YEAR 7 (2021) MONITORING REPORT

**ABBAY LAMM
STREAM AND WETLAND MITIGATION SITE**

Response to Monitoring Year 7 (2021) DMS Comments

Abbey Lamm Stream and Wetland Mitigation Site (DMS #96311)
 Cape Fear River Basin 03030002, Alamance County
 Contract No. 005790

Figure E1: Abbey Lamm 30-70 Percentile Graph for Rainfall

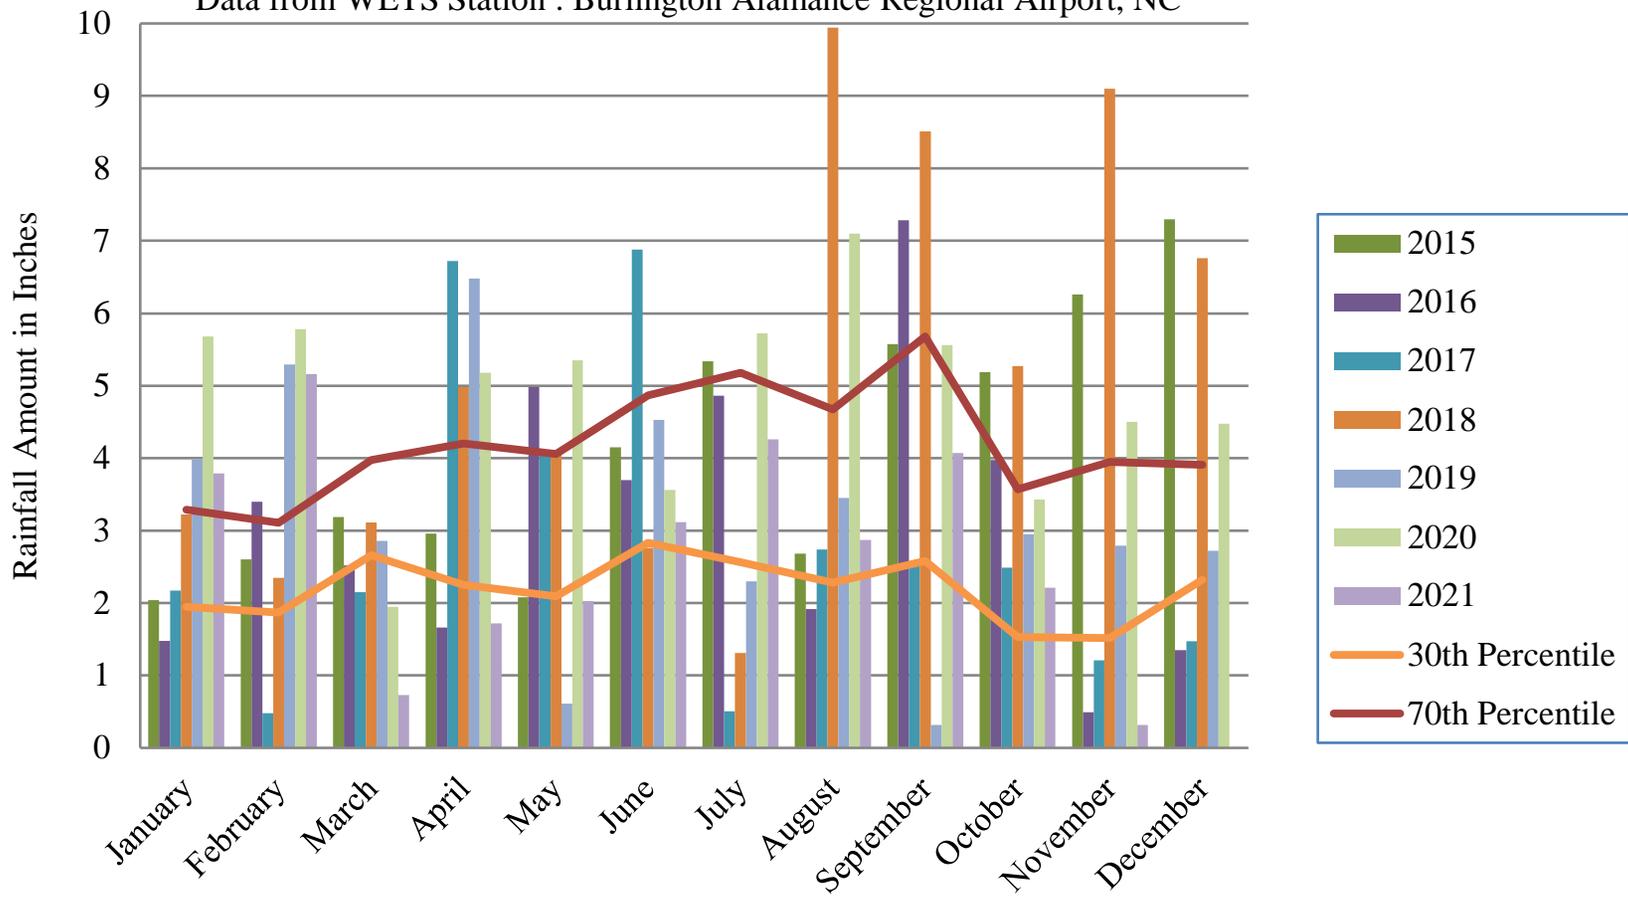
7. Please include a figure displaying the monthly rainfall data compared to the 30th - 70th percentiles.
 Figure E-1: 30-70 Percentile Graph for Rainfall was added to Appendix E.
